Lavender Garment Limited

11 December 2022

Observations

CHAPTER: 05. Conclusion & Recommendation:

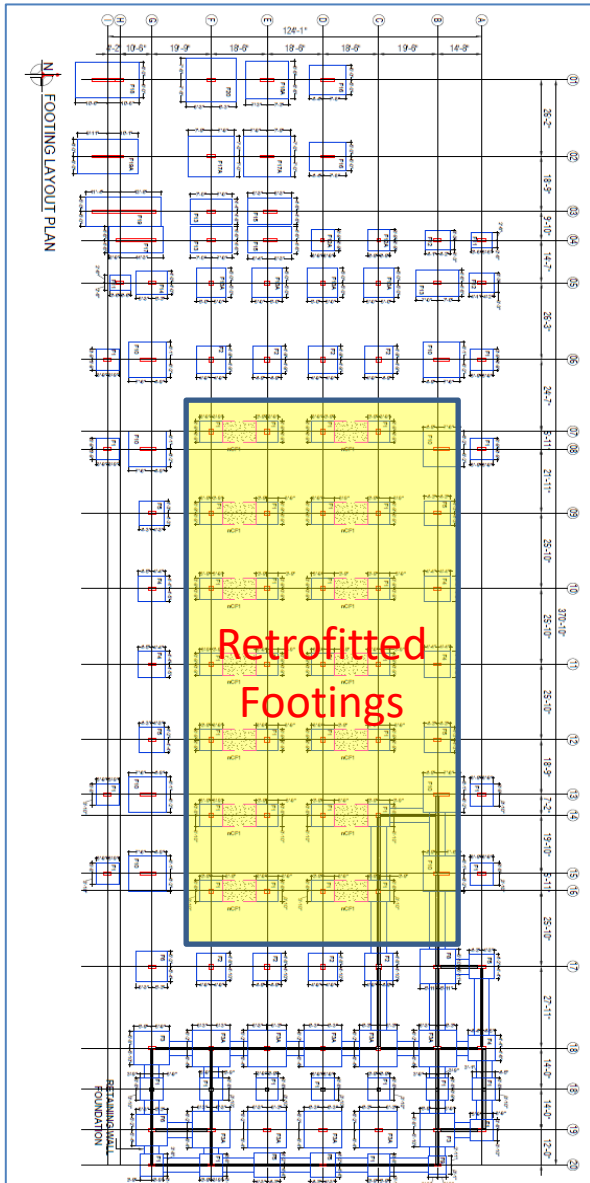
As per recommendation retrofitting has been suggested but no retrofitting drawings were found . Building engineer is required to check the recommendation carefully and provide retrofitting drawing where necessary.

A proper maintenance program and a load management system are required to be implemented according to floor load plan. Retrofitting must be completed according to approved retrofitting drawing.

Footing Layout

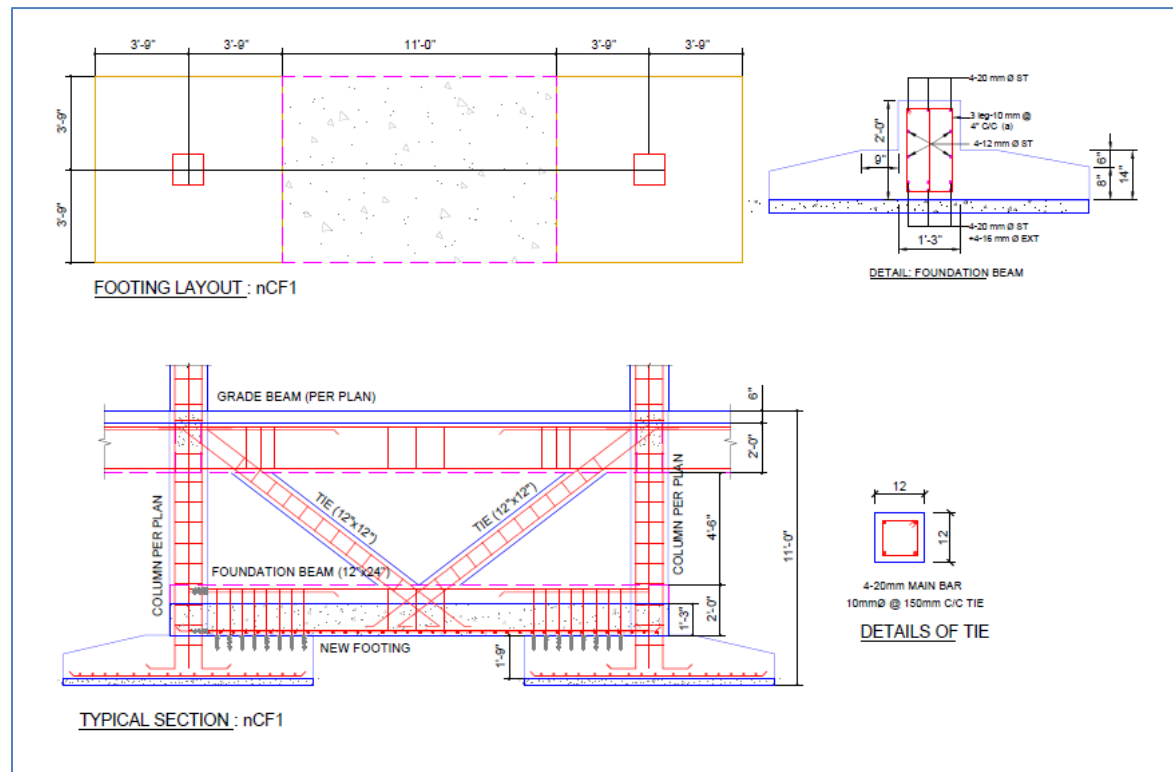
Reference/construction drawings were not available for the production Building. Also, some footings have been retrofitted at middle. Only a sectional details have been provided for these footings, but no pictorial evidence or material test report was found for the retrofitted footings. The building engineer is required to provide reference drawings with proper evidence of retrofitting works.

Undocumented Lightweight Roof

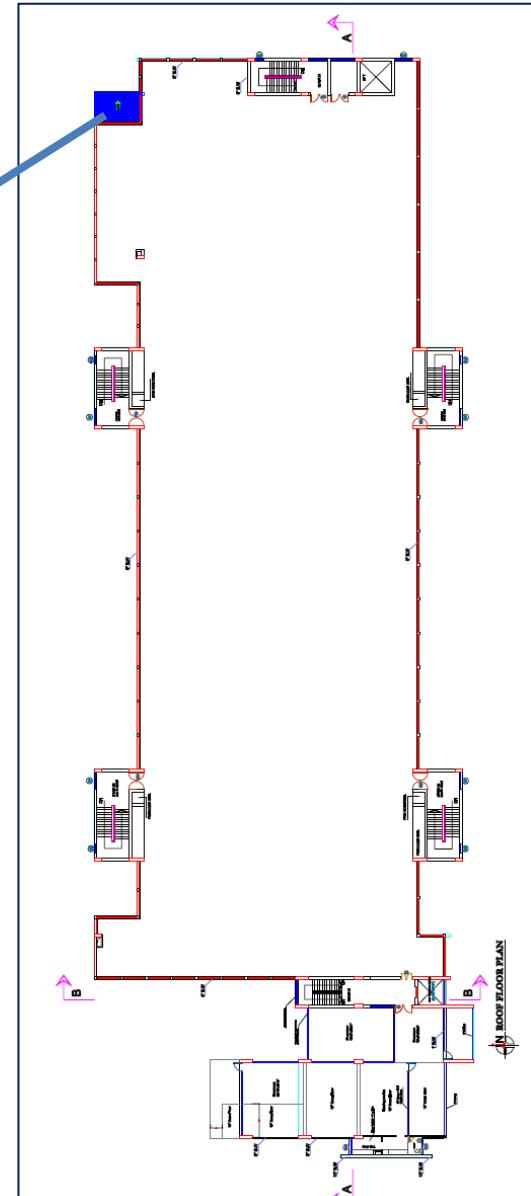
A small portion of steel light roof was found on 2nd floor of Building-1 at Northeast corner. No structural details was available for the roof. The building engineer to survey the structure and prepare as-built structural drawings with clear connection details.
